RATIONALE

NUT, FITTING, RETAINED

SAE AS4370C
SHEET 1 OF 5

ISSUED 1997-04 REAFFIRMED 2004-07 REVISED 2008-07

FIGURE 1 - NUT, FITTING, RETAINED

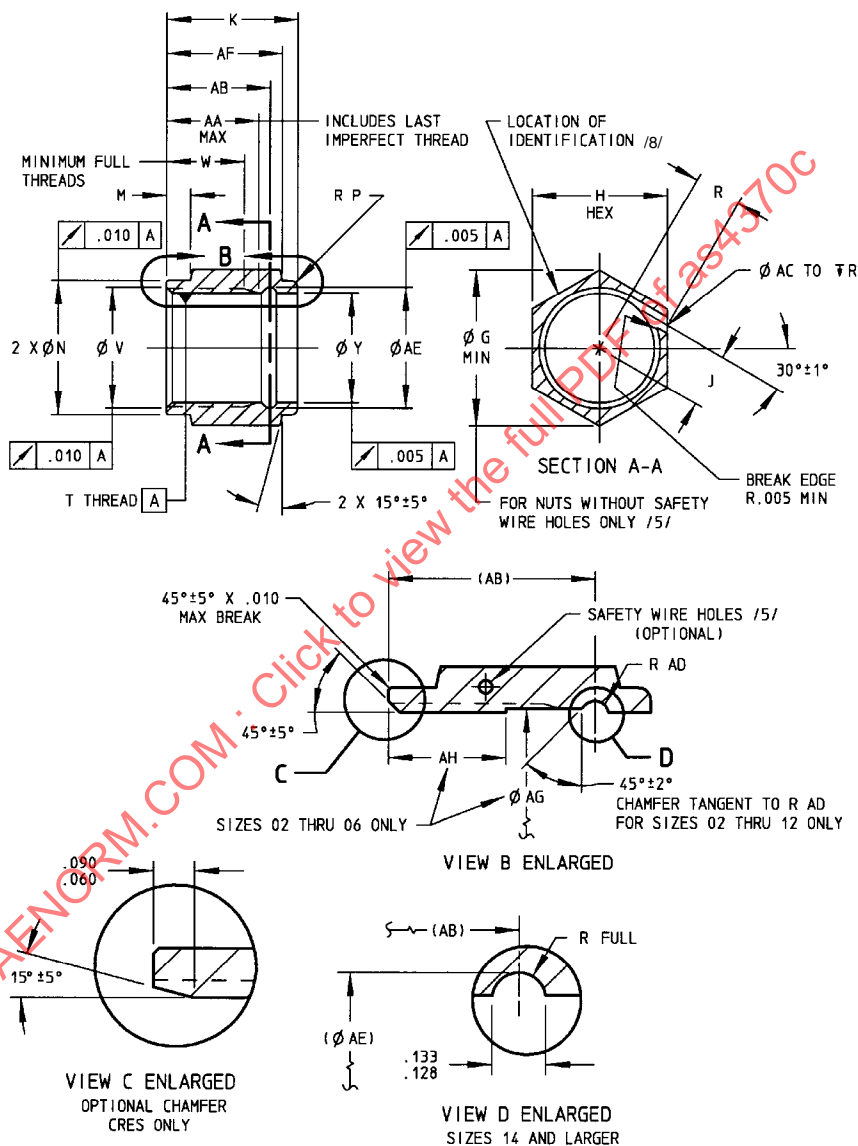
1. UPDATED THE SIZE 02 THRU 08 ACROSS CORNER HEX DIMENSIONS TO CURRENT ARP1942 DIMENSIONS - DIMENSION G IN TABLE 1A
2. ADDED CADMIUM NOTE WITH CURRENT DESIGN MANUAL WORDING.
3. ADDED CODE LETTER A MATERIAL SOLID FILM LUBRICANT AS1701 REQUIREMENT IN NOTE 4A AND DELETED "SUFFIX CODE X - SOLID FILM LUBE NOT REQUIRED".
4. ADDED MATERIAL CODE S IN NOTE 1 AND DELETED AMS-QQ-S-763 IN 1D, E, F, & G
5. ADDED DUPLEX SEAL FOR MATERIAL CODE D AND W PARTS WITHOUT SUFFIX N DRY FILM LUBRICANT IN NOTE 3C AND 3F.
6. REVISED NOTE 6, PROCURMENT SPECIFICATION AND COMBINE WITH NOTE 8
7. DELETED NOTE 8
8. DELETED NOTE 9: "INVENTORIED PARTS CONFORMING TO THE PREVIOUS ISSUES MAY BE USED TO DEPLETION"
